Public Comments Not Uploaded C.F. Nos. 22-0922-S1 and 22-0922-S2

**Re: C.F. Nos. 22-0922-S1 and 22-0922-S2; 650-676 S. San Vicente Blvd.;
Case Nos. CPC-2017-467-GPA-VZC-HD-SPR-1A and VTT-74865-1A;
ENV-2017-468-EIR (SCH No. 2020010172)**

1. *Parking Lifts Improperly Utilize Tandem Parking*

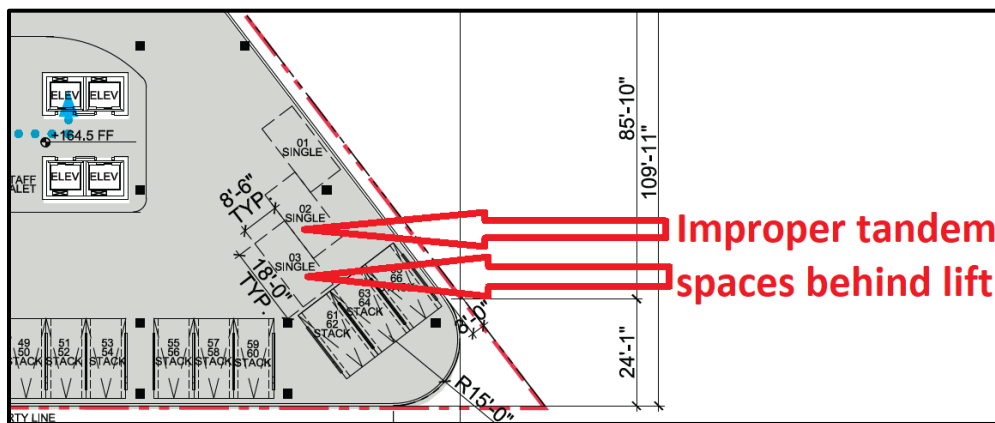
LAMC Section 12.21-A.4(h) requires that all required parking spaces shall be accessible. The Superintendent of Building has published the Parking Design Bulletin (**Exhibit 1**) to clarify the meaning of accessibility in the context of tandem and stacked parking.

H. The Project Exceeds its Requested FAR After Required Dedications are Provided

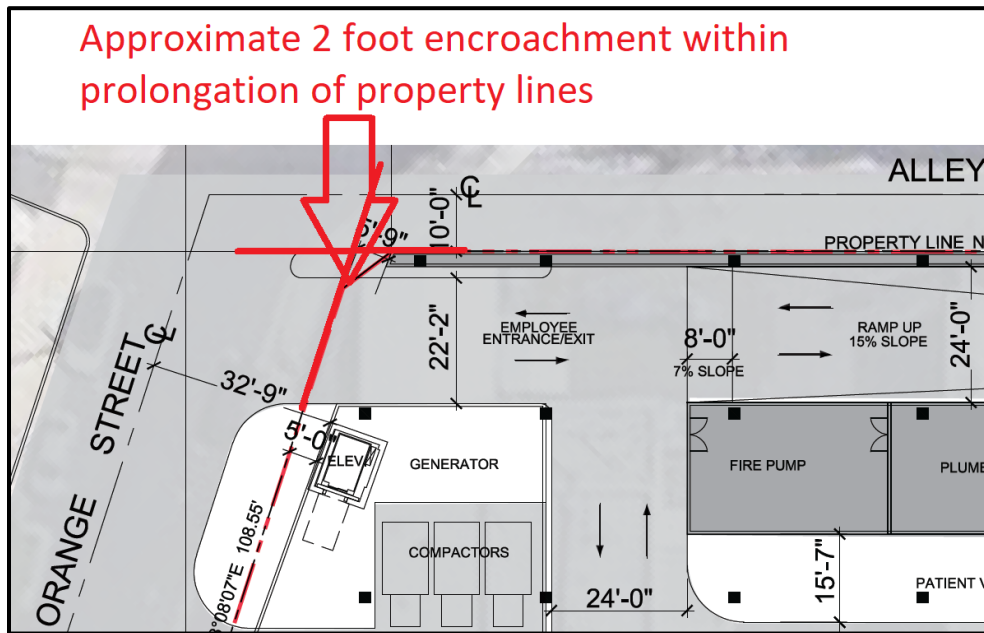
LAMC Section 12.37-G requires that the FAR of a Project is calculated from the net lot area after accounting for all required dedications. The City Planning Commission approved a Zone and Height District Change to permit a maximum FAR of 4.5 to 1, permitting 145,305 square feet of Floor Area on a site with a net area after dedications of 32,290 square feet. The required dedications on San Vicente Boulevard would reduce the lot area by approximately 3,253 square feet,⁴ resulting in a net lot area of 29,037 square feet. An FAR of 4.5 to 1 on this net lot area would permit a maximum of 130,666 square feet of Floor Area, or 14,638 square feet less than proposed. The Project's proposed 145,305 square feet of Floor Area on a 29,037 square foot net lot area would yield an FAR exceeding 5 to 1. The City Council lacks authority to approve an FAR materially greater than that requested in the application and approved by the City Planning Commission. Approval of a greater FAR than described in the DEIR would also result in a fatally inaccurate Project Description in violation of CEQA.
